Removal of London Stansted LYD 6R/5S SIDS

EGSS LYD SIDs
Stage 4 Update and Submit
Step 4B

Airspace Change Proposal
V1.2

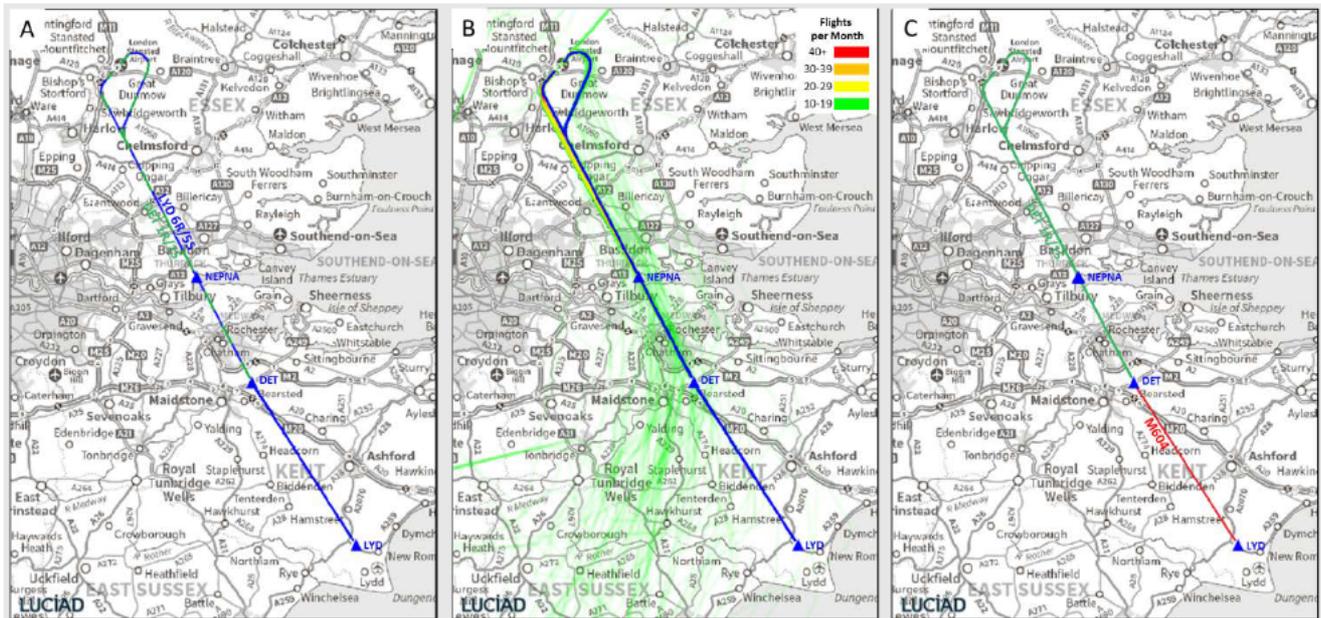
This ACP proposes that aircraft currently departing London Stansted using the LYD 6R/5S SIDs will fly the coincident DET 1R/1S SID. This SID finishes at DET. The remaining portion of the LYD SID will be replicated by extending UK ATS Route M604 from DET to LYD to replace the removed portion of the LYD SIDs. This new segment of M604 will be Route Availability Document (RAD) restricted so that it is only available to those flights which would have flown the defunct LYD 6R/5S SIDs.

These changes will maintain connectivity to the UK ATS network whilst ensuring there will be no changes to the frequency nor to the vertical or lateral dispersion of flights. The current LYD and DET SID routes along with a density plot of aircraft flying the LYD SIDs for June 2019 and proposed changes are shown in Figure 3.

Figure 4: LYD/DET SID Chart AD2.EGSS-6-4 with proposed deletions highlighted red and updates highlighted in green.

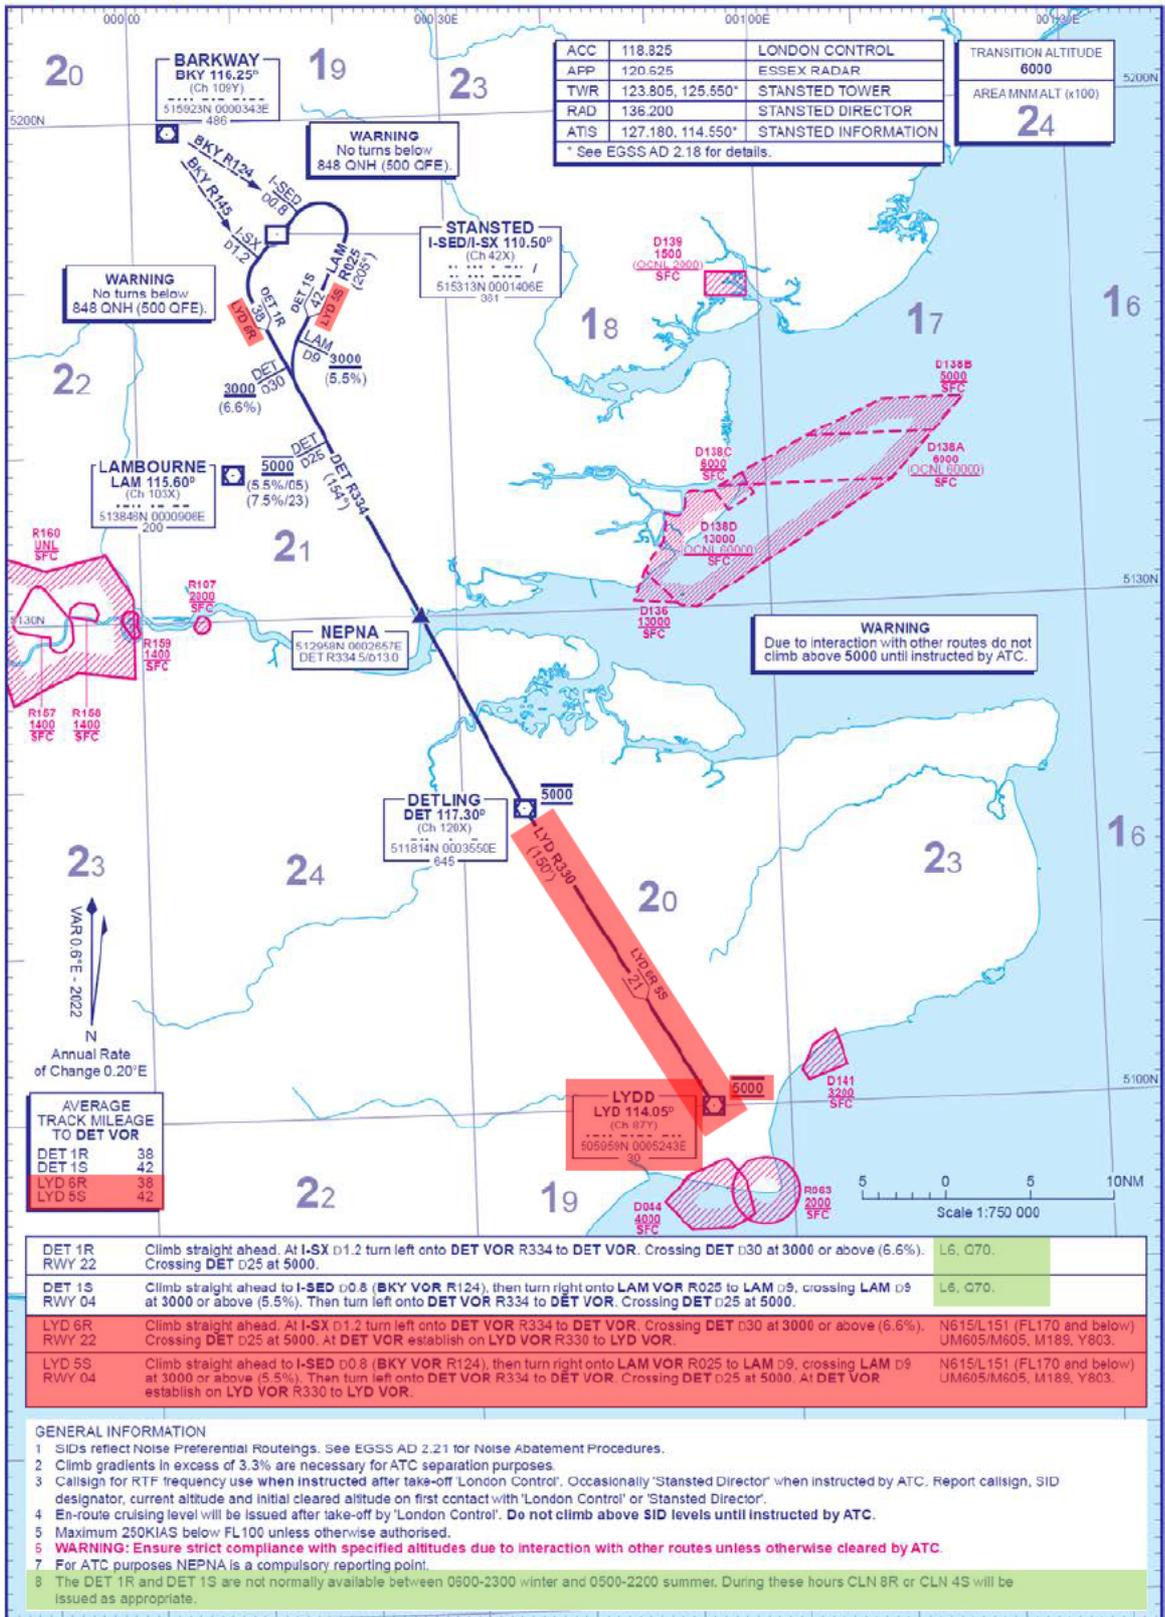
Changes to EGSS AD2.24 AD 2.EGSS-6-4 STANDARD DEPARTURE CHART - INSTRUMENT (SID) DETLING/LYDD - ICAO

Currently the DET 1R/1S SIDs are not available H24, they are unavailable between 0500-2200 summer and 0600-2300 winter. There is no associated restriction with the LYD 6R/5S SIDs. General information on the DET 1R/1S will be updated as follows:

- 8) The DET 1R/1S SIDs are available H24 for aircraft routing via M604- LYD.
- 9) For Departures routing via L6, Q70, the DET 1R/1S SIDs are available between 2200-0500 summer and 2300-0600 winter. During these hours the CLN 8R or CLN 4S will be issued as appropriate.

The connectivity column on the plate will be updated to read:

M604 (See note 8)

L6, Q70 (See Note 9)

References to the LYD DVOR and LYD SIDs will be removed

The proposed changes to the LYD/DET SID Chart AD2.EGSS-6-4 are shown in Figure 4 below:
